SERVICE BULLETIN

NACELLE - EXHAUST - NO. 1 LATCH OPEN INDICATOR STAINLESS GUIDE PAD INSTALLATION, THRUST REVERSER - MODIFICATION OF - CATEGORY CODE 6 - MOD.NAC-78-0092

V2500-NAC-78-0092

No. 1 Latch Open Indicator Pad Removal/Installation (Service Bulletin Part 2)
Fig.2

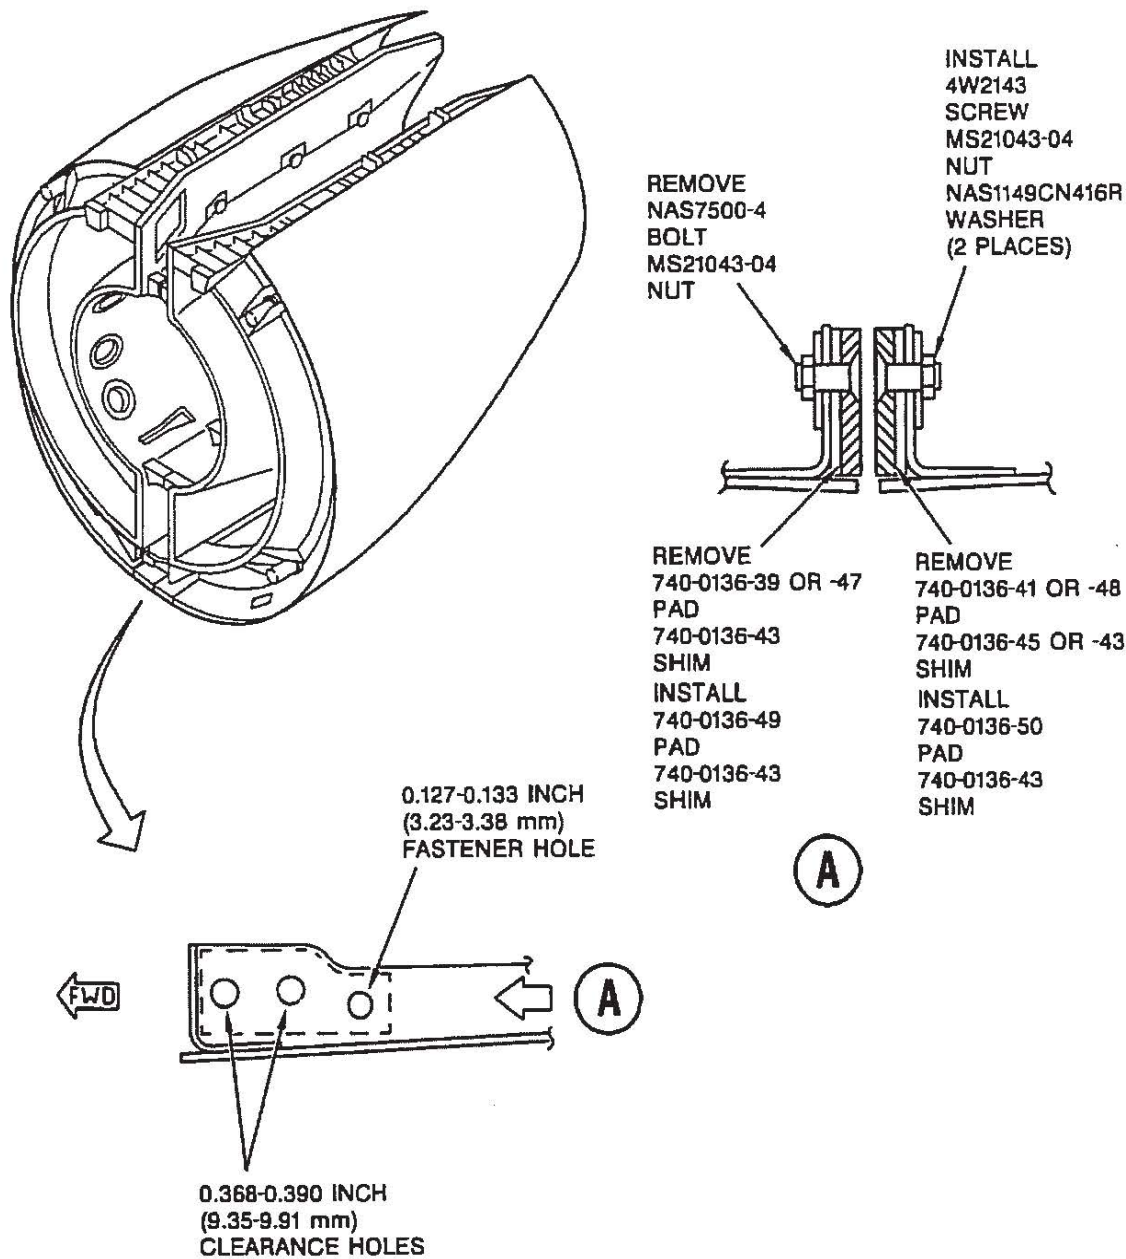
(1) Remove the stainless steel guide pads.

(a) Remove the MS21043-04 nuts, NAS7500-04 bolts, pads, and shims from the thrust reverser halves. Discard the pads and shims. Keep the nuts for later installation. Keep the bolts for other aircraft installations.

(2) Install the 740-0136-49/50 guide pads and 740-0136-43 shims.

- (a) Hold the 740-0136-49 pad and 740-0136-43 shim together. Make sure the shim is against the flat (not beveled) side of the pad. Backdrill the two 0.368-0.390 (9.35-9.91 mm) holes and one 0.127-0.133 inch (3.23-3.38 mm) hole through the shims. Refer to Figure 2.
- (b) Hold the 740-0136-50 pad and 740-0136-43 shim together. Make sure the shim is against the flat (not beveled) side of the pad. Backdrill the two 0.368-0.390 inch (9.35-9.91 mm) holes and one 0.127-0.133 inch (3.23-3.38 mm) hole through the shims.
- (c) Temporarily install the pads and shims with the NAS1102E04-7 screws, NAS1149CN416R washers, and MS21043-04 nuts. Adjust the clearance between the latch open indicator and the pads when the thrust reverser and engine are installed on the aircraft. Refer to the A320/A321 Aircraft Maintenance Manual, Chapters 78-32-01, -02, -03, and -04.

No. 1 Latch Open Indicator Pad Installation (Service Bulletin Part 3)
Fig.2

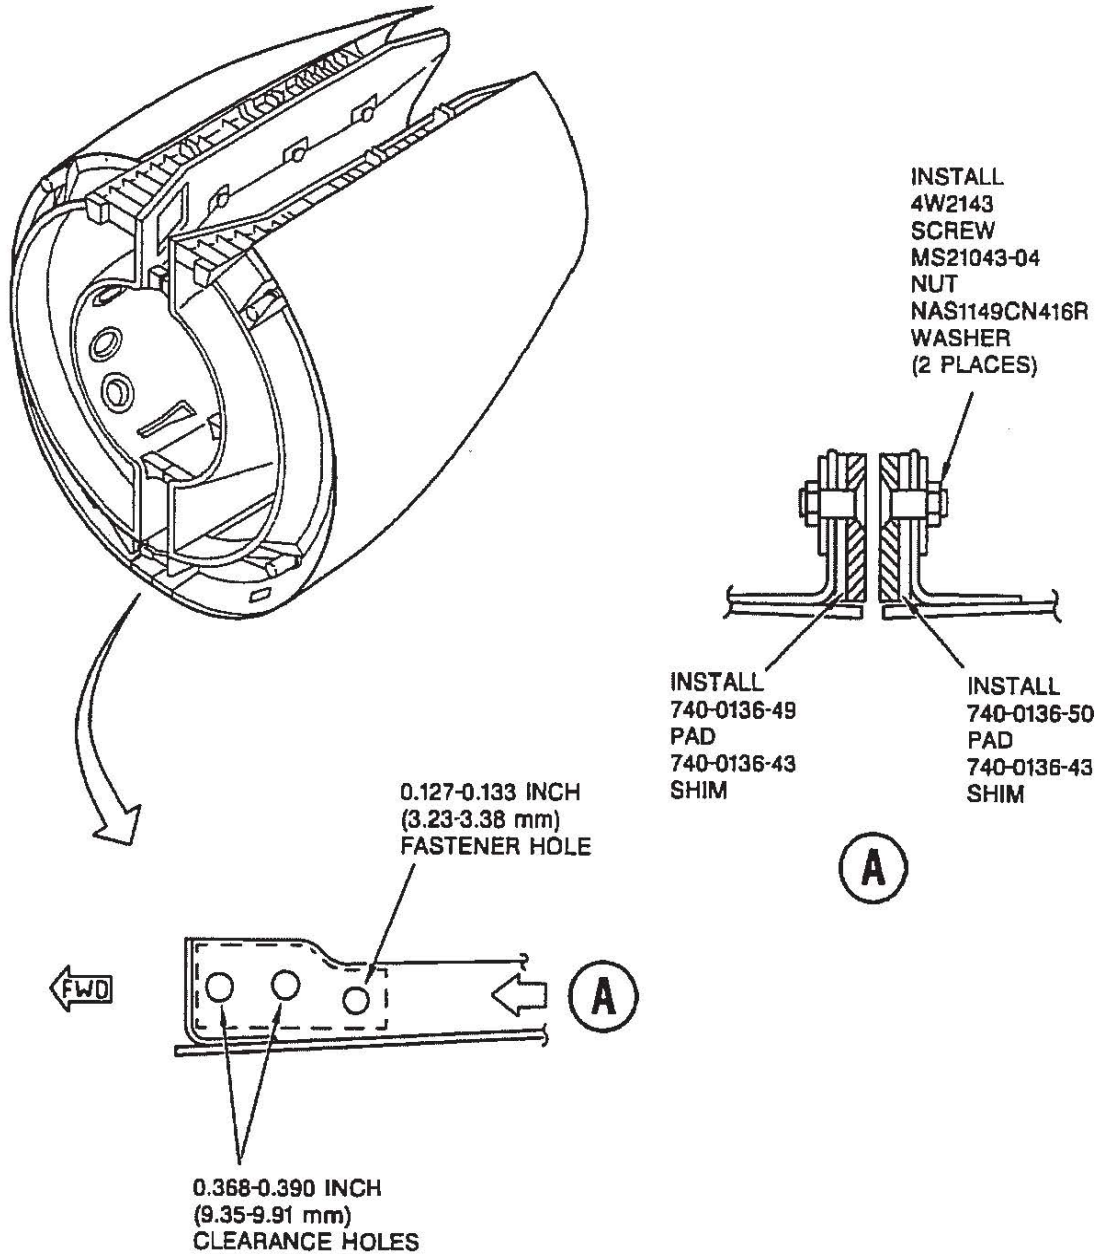
- (1) Hold the 740-0136-49 pad and 740-0136-43 shim together. Make sure the shim is against the flat (not beveled) side of the pad. Backdrill the two 0.368-0.390 (9.35-9.91 mm) holes and one 0.127-0.133 (3.23-3.38 mm) inch hole through the shims. Refer to Figure 2.

- (2) Hold the 740-0136-50 pad and 740-0136-43 shim together. Make sure the shim is against the flat (not beveled) side of the pad. Backdrill the two 0.368-0.390 inch (9.35-9.91 mm) holes and one 0.127-0.133 inch (3.23-3.38 mm) hole through the shims.

- (3) Put the pads and shims on the thrust reverser halves and back drill a 0.127-0.133 inch (3.23-3.38 mm) hole through the lower track.
- (4) Temporarily install the pads and shims with the NAS1102E04-7 screws, NAS1149CN416R washers, and MS21043-04 nuts. Adjust the clearance between the latch open indicator and the pads when the thrust reverser and engine are installed on the aircraft. Refer to the A320/A321 Aircraft Maintenance Manual, Chapters 78-32-01, -02, -03, and -04.
